Determination 2008/51

Building consent for a house at 25 Emmett Street, Herne Bay, Auckland

Figure 1: Long section through house

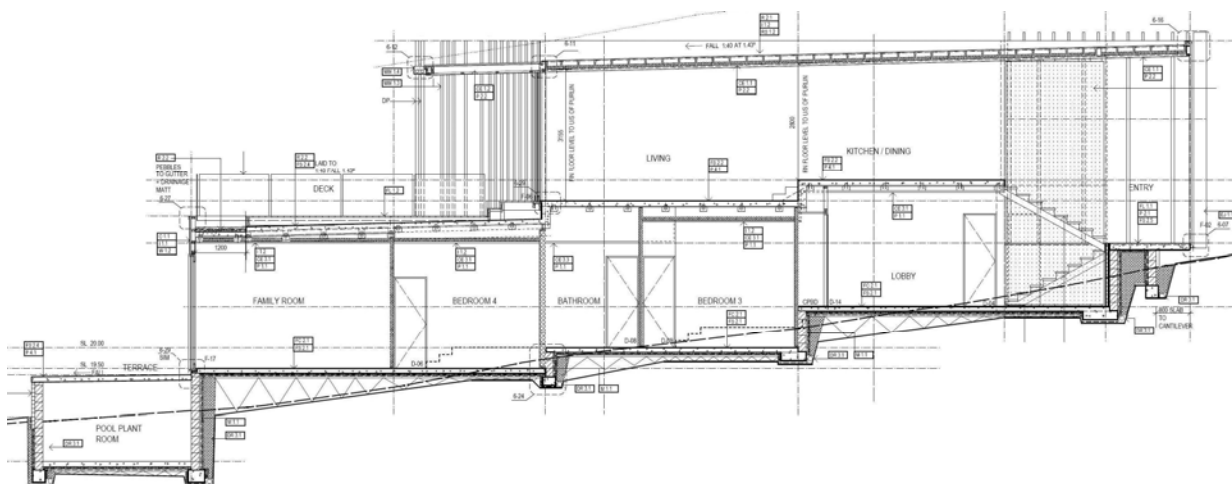
- 1.2 The application is in respect of a decision by the authority to refuse to grant a building consent for the construction of a proposed house unless changes are made to the design of the roof, on the grounds of its inability to shed water.

2.2.1 The roof falls along the length of the house at a fall of 1:40 towards a membrane-lined gutter across the north end, at the edge of the canopy over the lower deck area.

- 7.5 I note that the house is designed as a structure that is considerably more rigid than conventional timber framing, with the steel roof beams parallel to the fall of the roof and the short span timber joists across the line of fall. In such a situation, I consider that there is little likelihood of the roof deflecting in such a way as to cause 'ponding' on the membrane surface.

- 8.1 In accordance with section 188 of the Building Act 2004, I hereby determine that the upper roof to this building complies with Clause E2 of the Building Code, and reverse the authority's decision to refuse to grant the building consent.
